House 24.

House 24

Following discussion between M Dysart₃ and C Woodrow
on 24 September, C Woodrow now advises:

LOFT

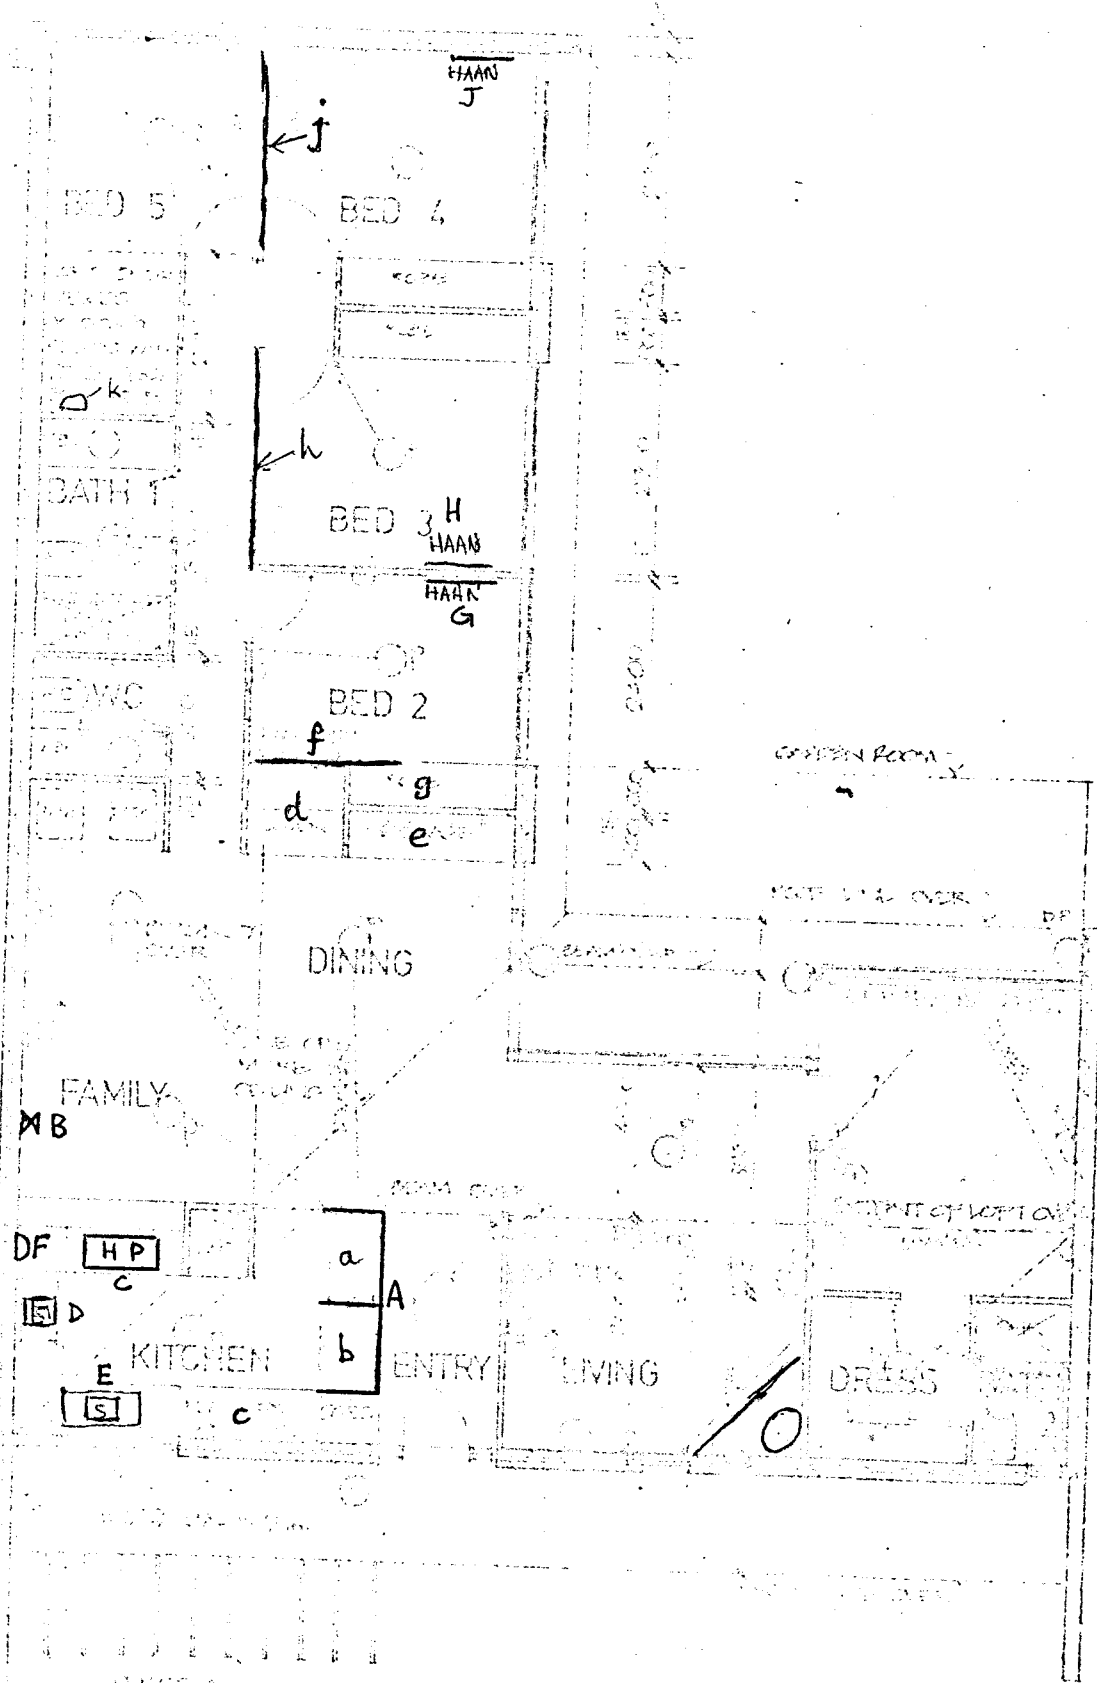
Loft consists of four sections 6 1/2' in width.

Post-contract
Would need exposed conduit
1. power point required at loft floor level in centre of each loft section adjacent to external wall. \$150

2. one downward recessed light ~~in centre of~~ in ceiling in each section close to external wall.

yes.
